Proposed Minor Relaxation of Building Height Restriction for Permitted Industrial Use cum Public Vehicle Park
Fanling Sheung Shui Town Lot 245, On Kui Street, Fanling
(Section 16 Planning Application No. A/FSS/306)

- Further Information No. 1 -

Items	Comments	Responses
1	Comments from Fanling, Sheung Shui & Yuen Long East District Planning Office, Planning Department received on 22 July 2026 (Contact Person: Mr. CHENG Chi Chiu, David, Tel: 3168 4046)

Drawing Title
TREE TREATMENT PLAN (FOR INFORMATION ONLY)

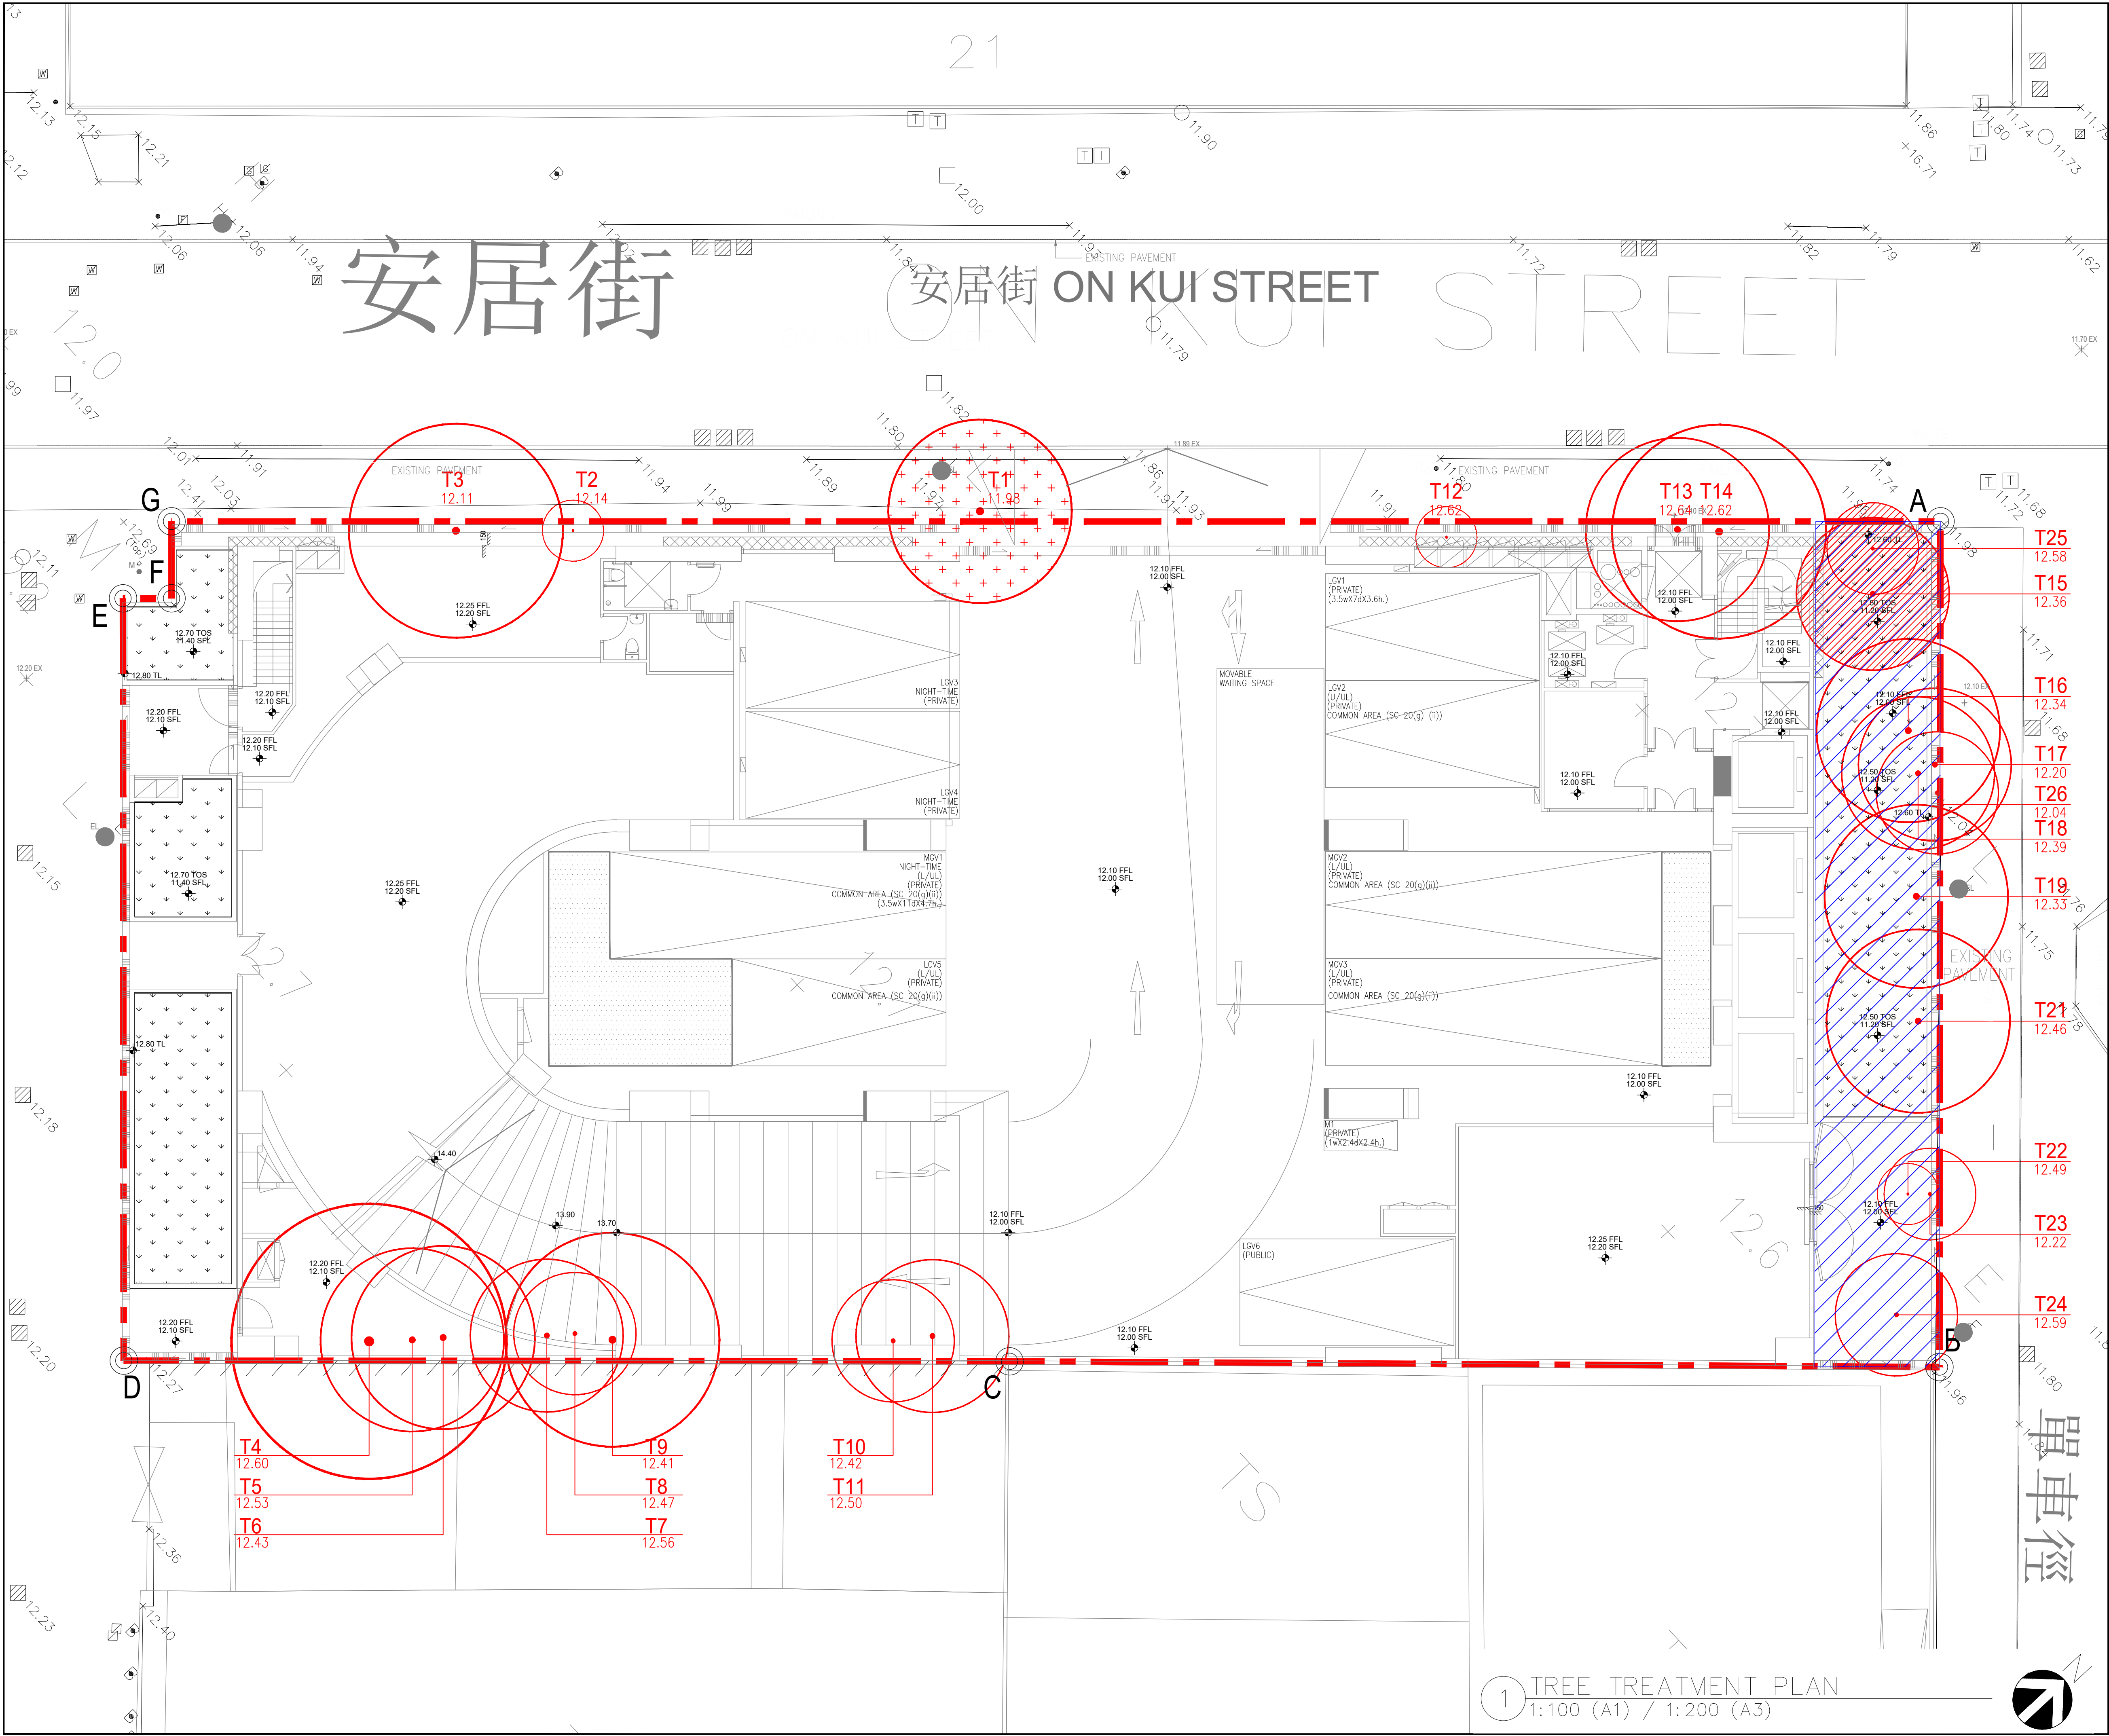
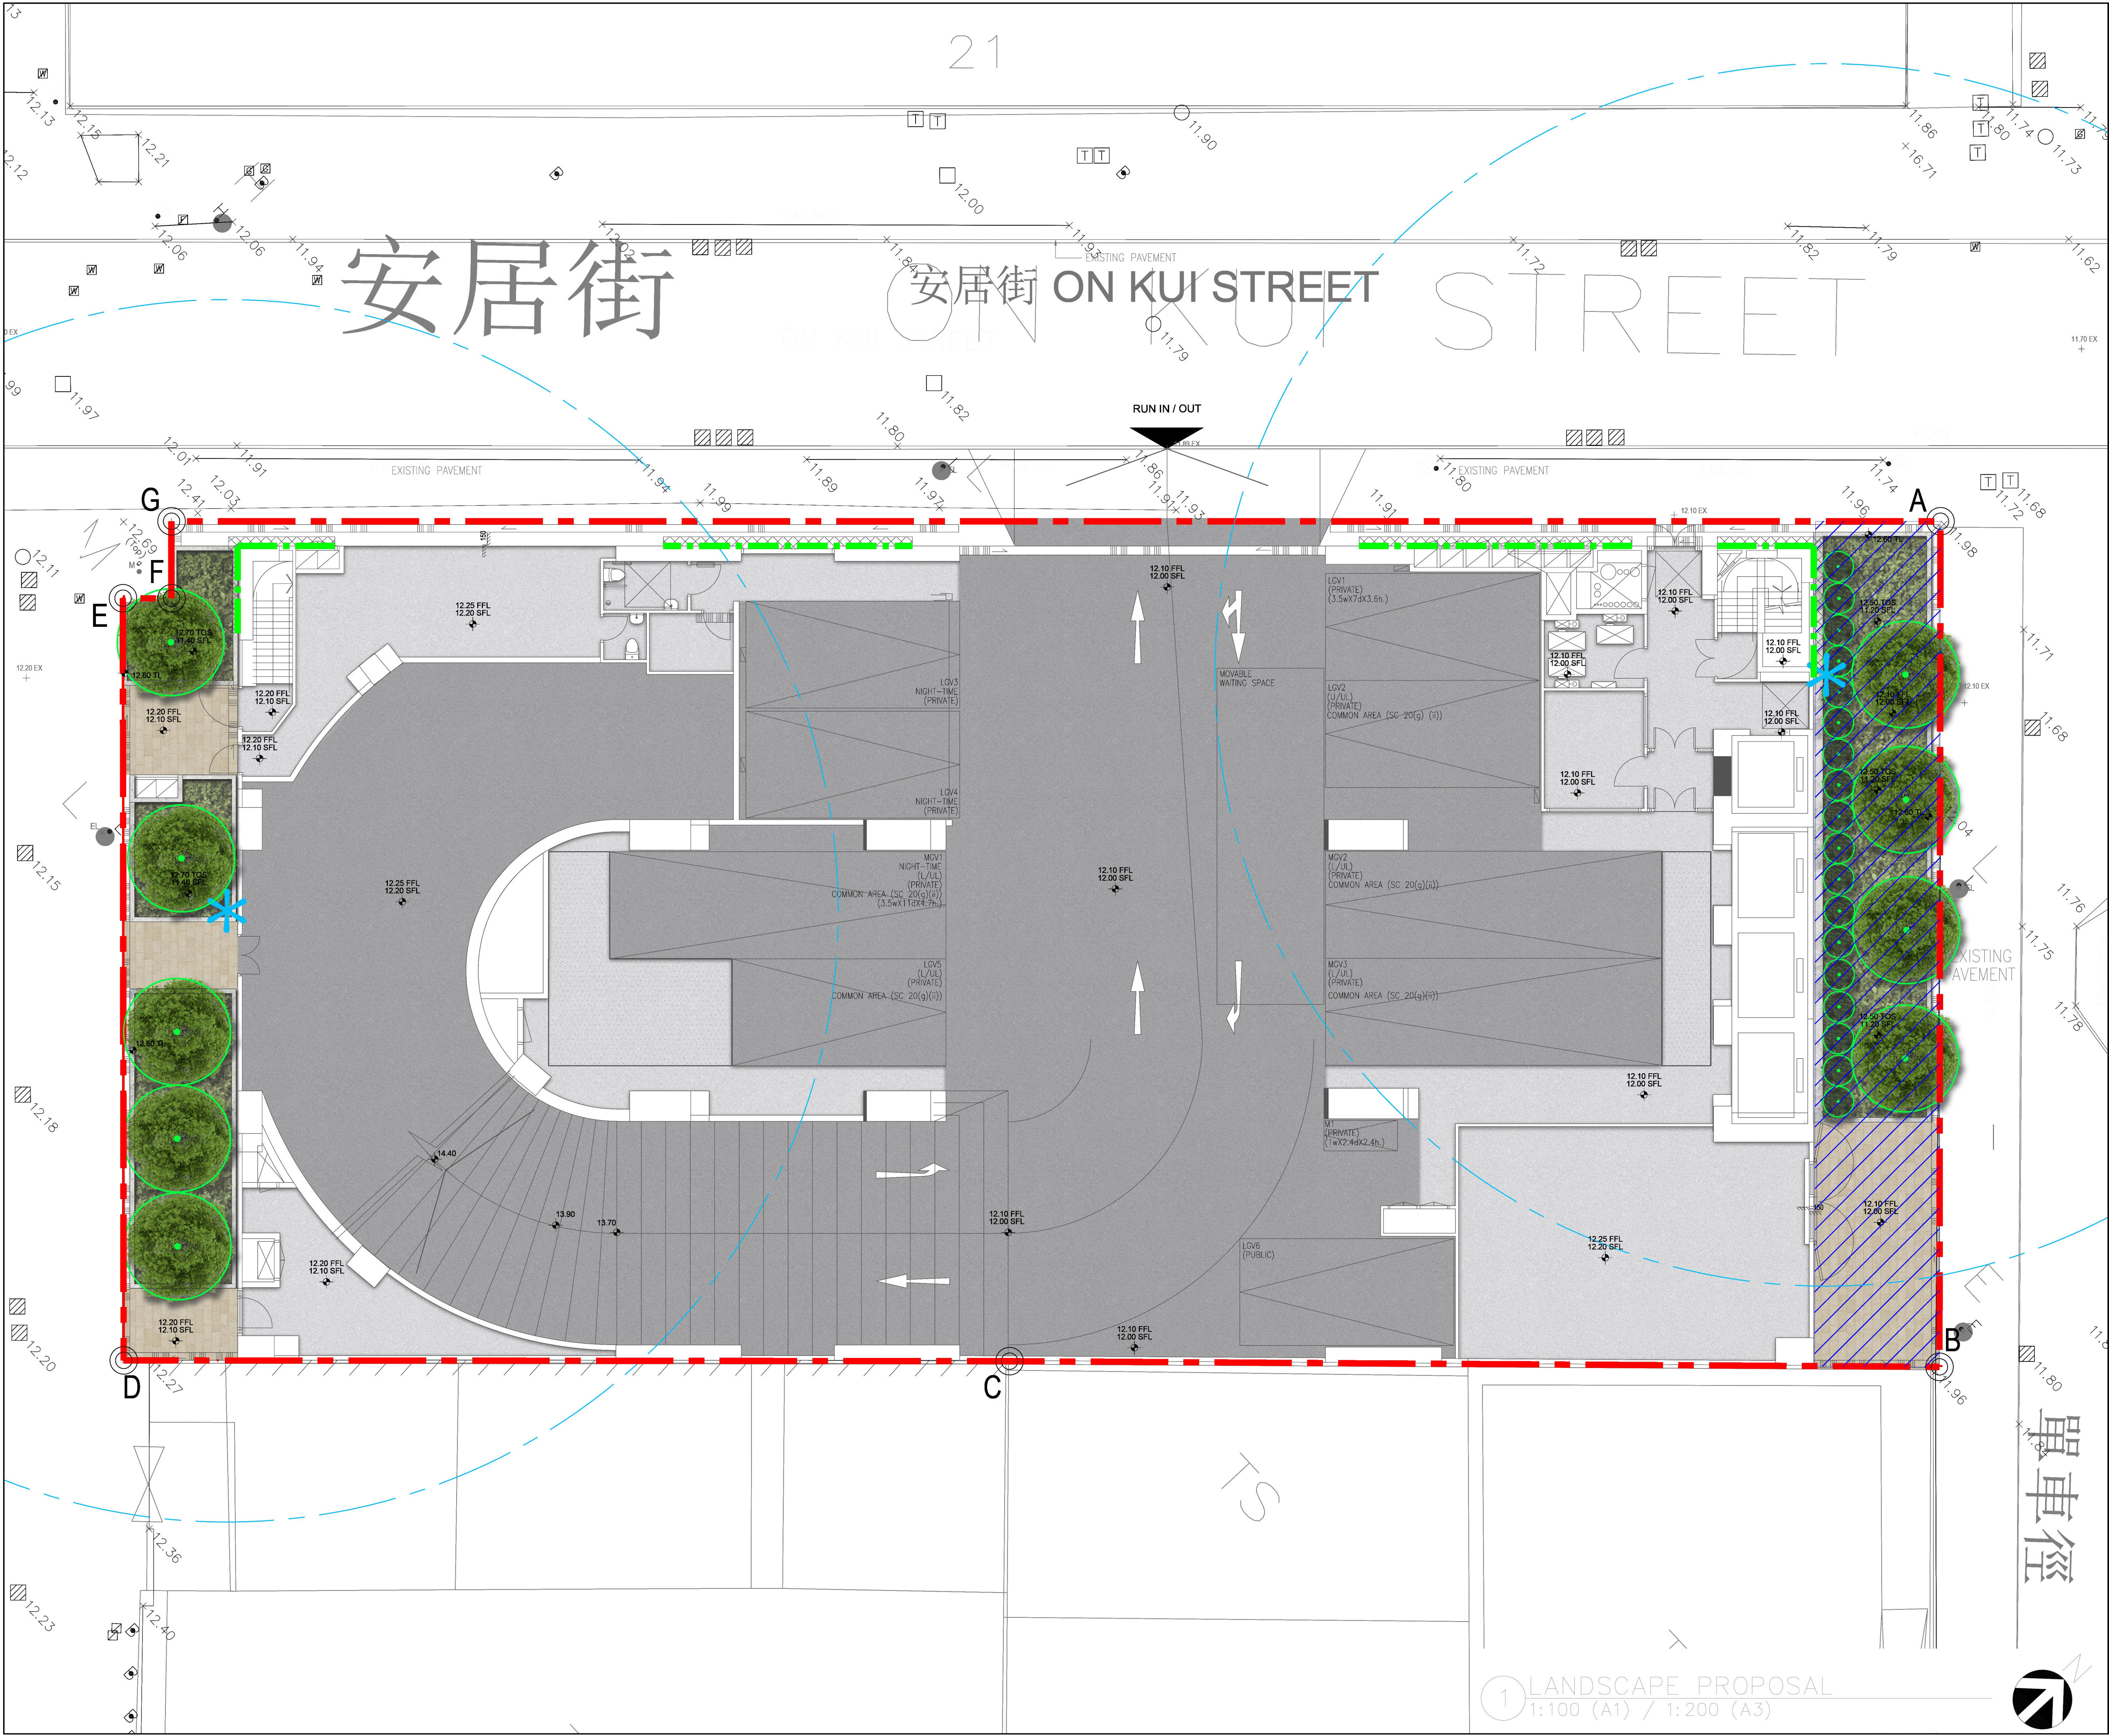
3.1	With reference to the aerial photo and site photos, the site was largely formed. According to our site visit, some common trees were observed along the site boundaries. According to the Supporting Planning Statement, 24 existing trees (including 2 dead trees and 2 emergency felled trees) will be felled and 27 compensatory trees will be planted within the future development, to achieve a minimum 1:1.125 compensation ratio. According to the Proposed Scheme, greenery areas and vertical greening were proposed. According to the Application Form, no tree felling will be involved.	Noted. All trees within Pink Area and Green Area were approved "Felled" by LandsD. With reference to the enclosed Landscape proposal, an updated planting proposal (Annex D refers) should be referred.
4	Further Comments from Fanling, Sheung Shui & Yuen Long East District Planning Office, Planning Department received on 18 August 2026 (Contact Person: Mr. CHENG Chi Chiu, David, Tel: 3168 4046)

4.1	According to the aerial photo, some tree canopies are encroaching both within and outside the site. It is understood that the applicant has submitted a tree survey and proposed some tree treatment measures. In this regard, please advise whether the tree survey and tree treatment measures have also taken into account trees located outside the site (apart from tree T1), if any, including their tree canopies. If there are any trees located outside the site with tree canopies encroaching onto the site that may affect the proposed development, they should also be taken into account.	For trees outside the application site but inside adjacent lot, which will be tackled with the adjacent lot owner for tree crown trimming when required, following the standard procedure of LAO PN 6/2023.
